## SERVICE INFO 2024/01: Product change, Particle filter SP015757

Powered air purification respirator unit PFU 210e PARTICLE FILTER SP015757 (2).

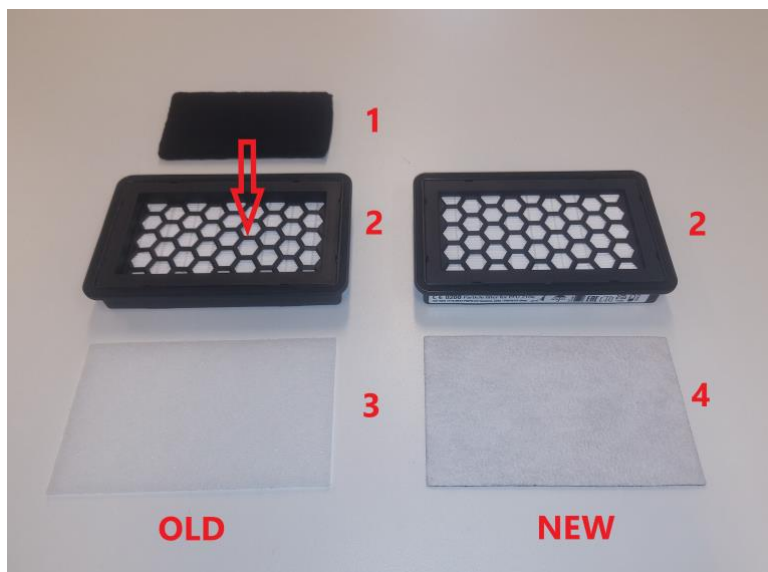
Particle filter has been improved (more paper) for better air flow and longer battery life. In old system the odor filter (1) was fitted inside particle filter (2).

New particle filter (2) has a thicker inner section so old odor filter (1) would prevent closing the PFU 210e filter cover. New type particle filter (2) can be used with new type odor pre-filter (4) that is installed after the spark filter and before the particle filter. In this case pre-filter is not used.

When change a new type of particle filter SP015757 to PFU 210e respiration unit.

SP015757	PARTICLE FILTER
SP027163	ODOR PRE-FILTER
